701 5th Avenue North | Seattle WA 98109

DESIGN REVIEW: Recommendation Proposal
(DPD #3015918)

Prepared for F&M Development
September 21, 2016

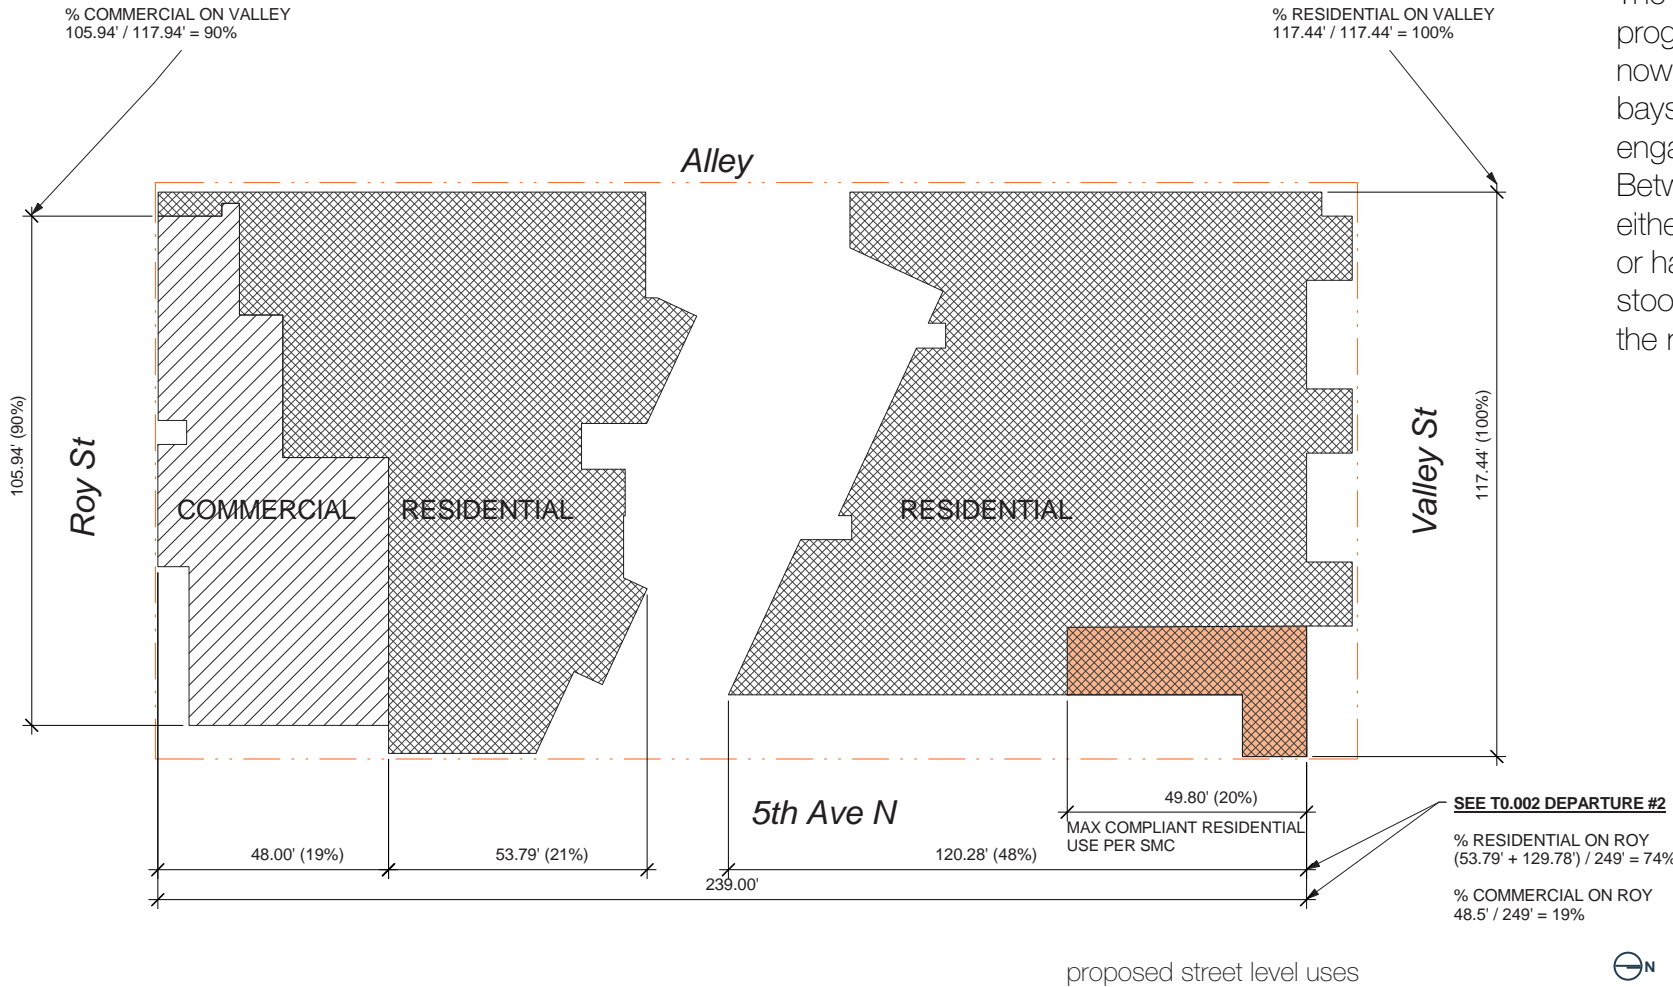
"The board demonstrated partial support of the departure for greater than 20 percent residential use along 5th Ave. N, citing the guidance given on resolving the uncertain character of the space."

Further Justification:
The portion of residential program along 5th Ave is now defined by projecting bays and balconies to engage the street edge. Between each bay is either a landscape buffer, or hardscape entry stoops, to further reinforce the residential character.

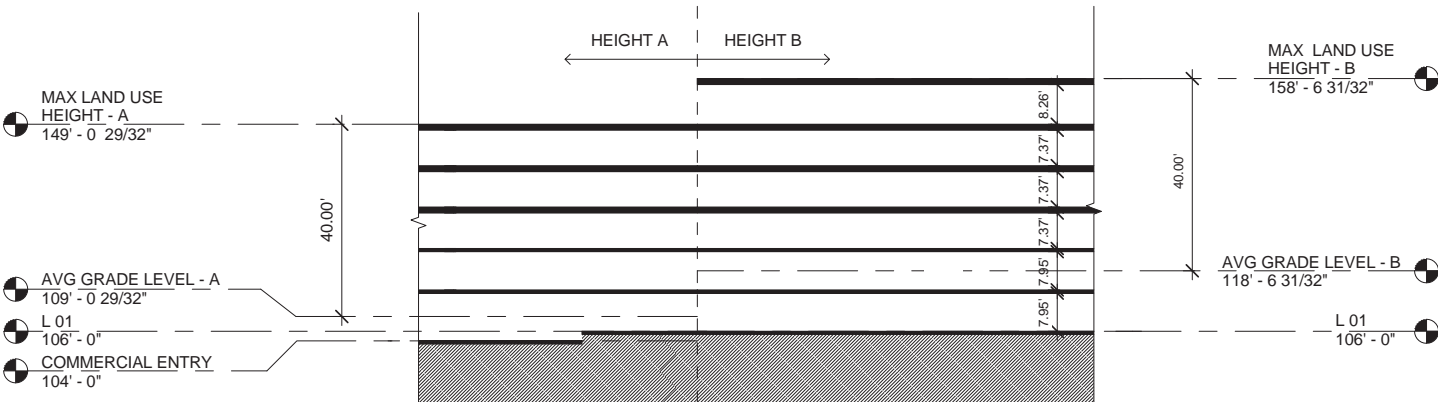
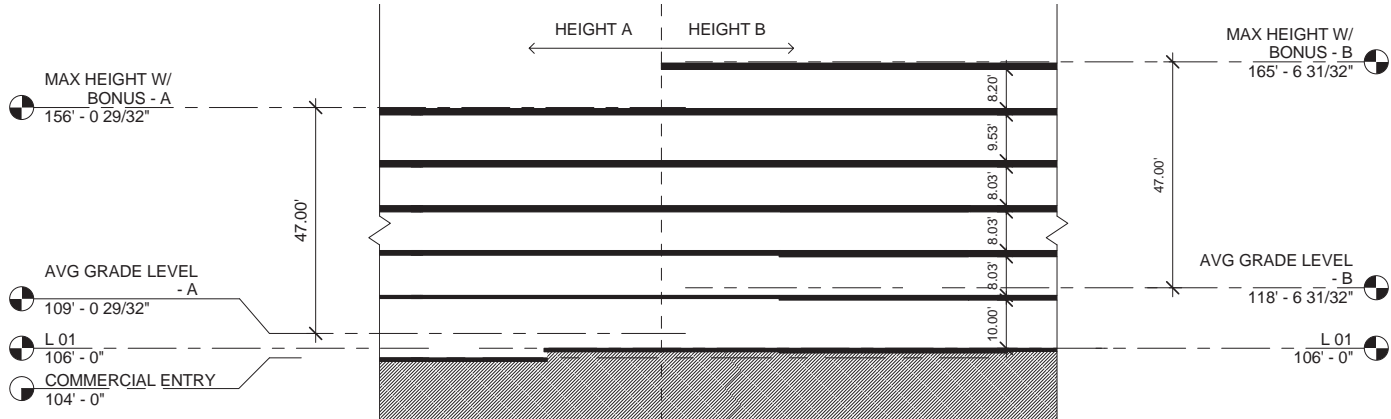
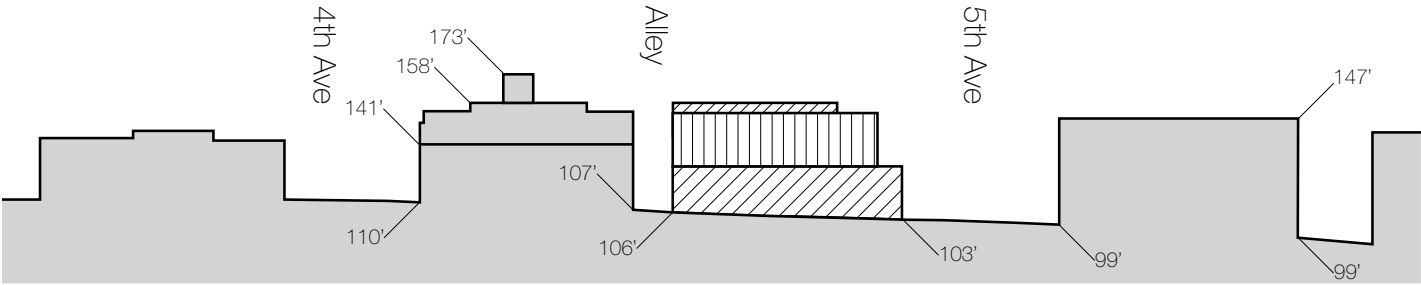
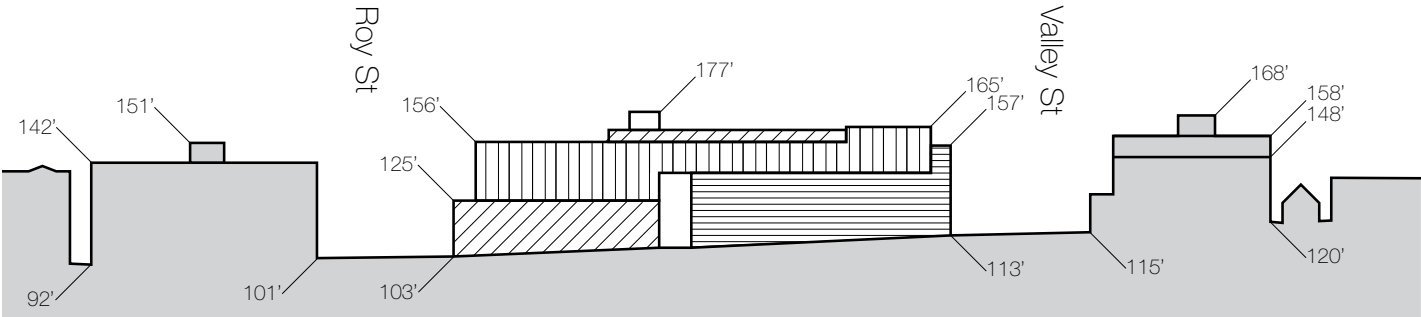
"The board indicated preliminary support for the departure, as Option 2 and Option 3 are set back at least 6 feet at the upper level, reducing the impact of the structure height on the streetscape below."

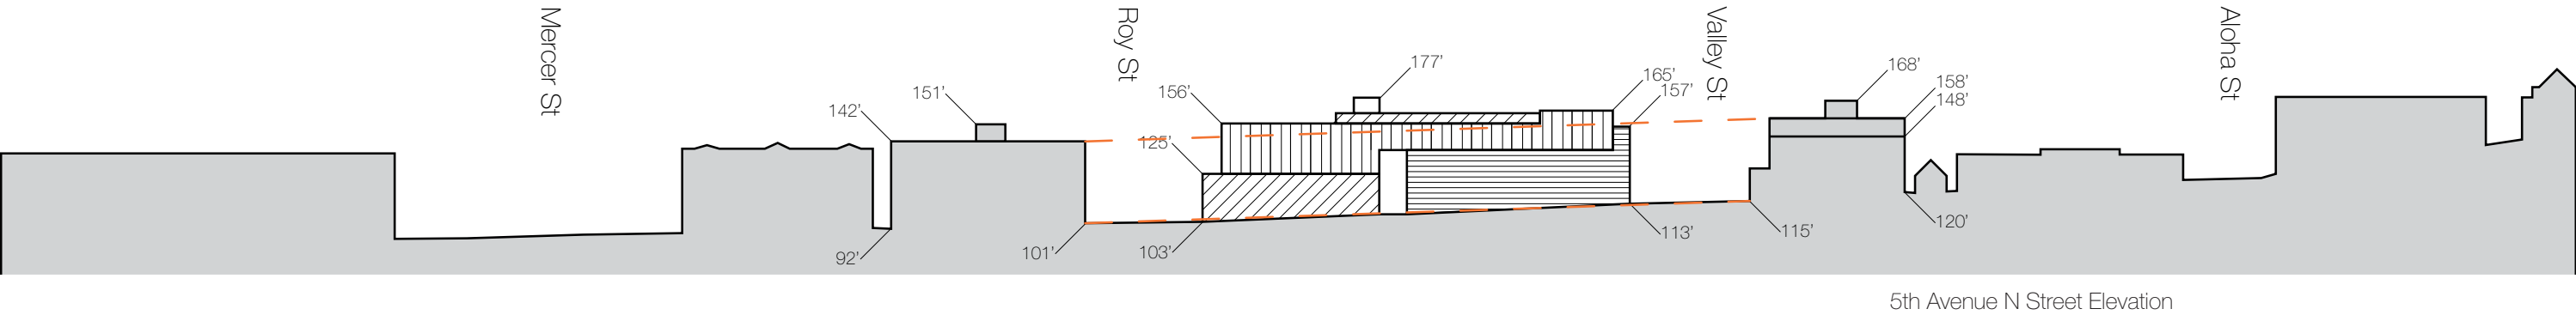
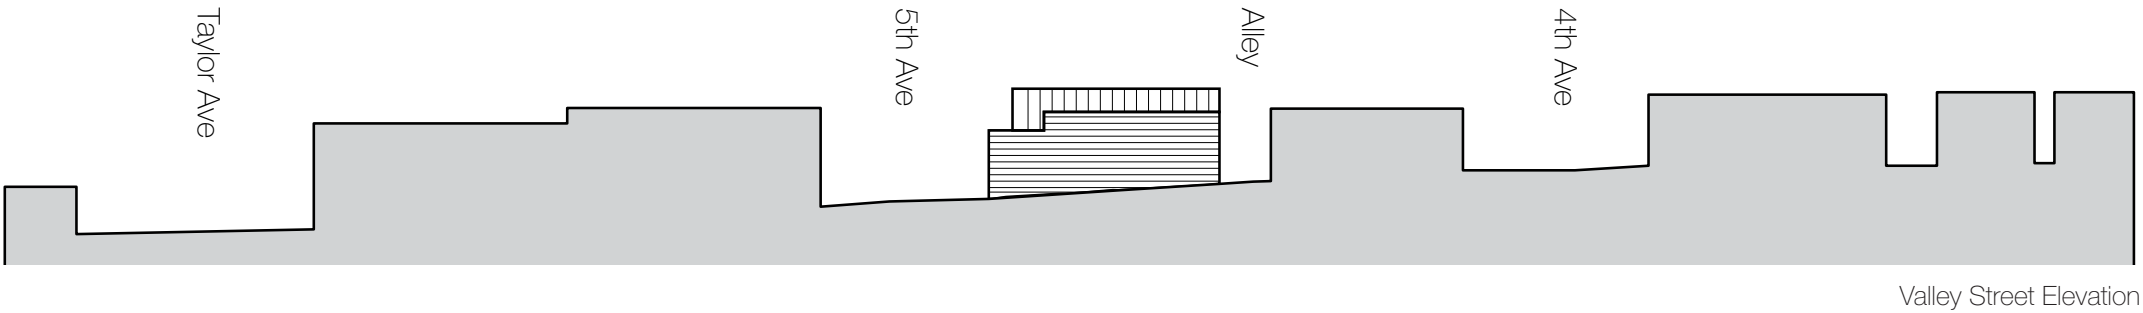
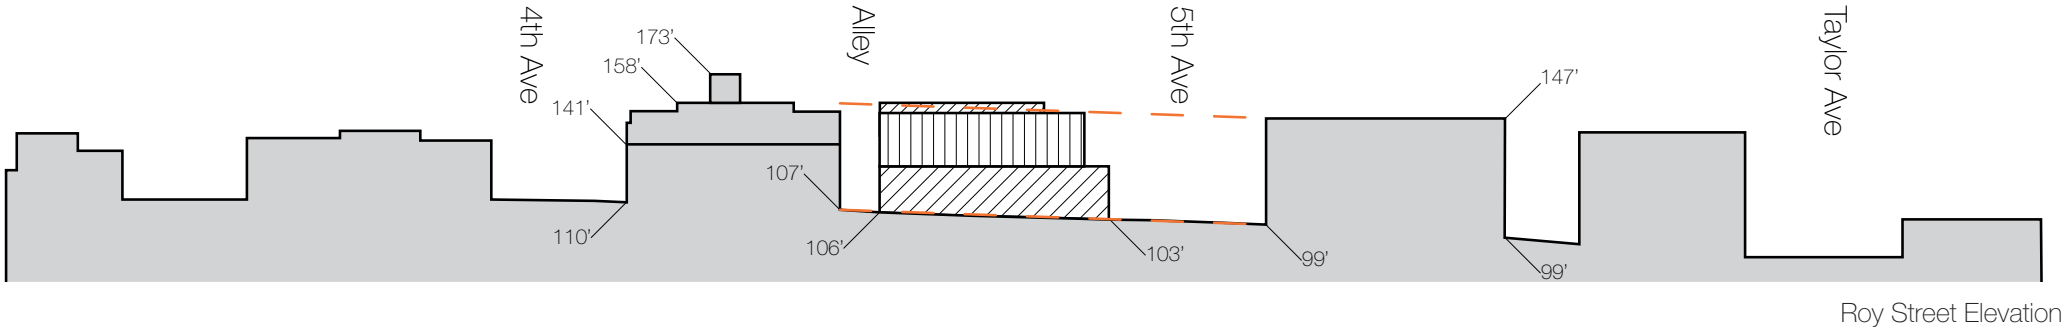
“The Board supported the setback individual townhouse unit entries and generous landscape buffers.”

Further Justification:
The exterior bays wrap the corner of 5th Ave and Valley St, which help strengthen the residential character of Valley and provide stronger continuity across the building massing. Landscape elements including planters and walk-up patios are implemented to soften the building edge where it meets the sidewalk, while also providing a defensible space barrier for the future residential tenants.
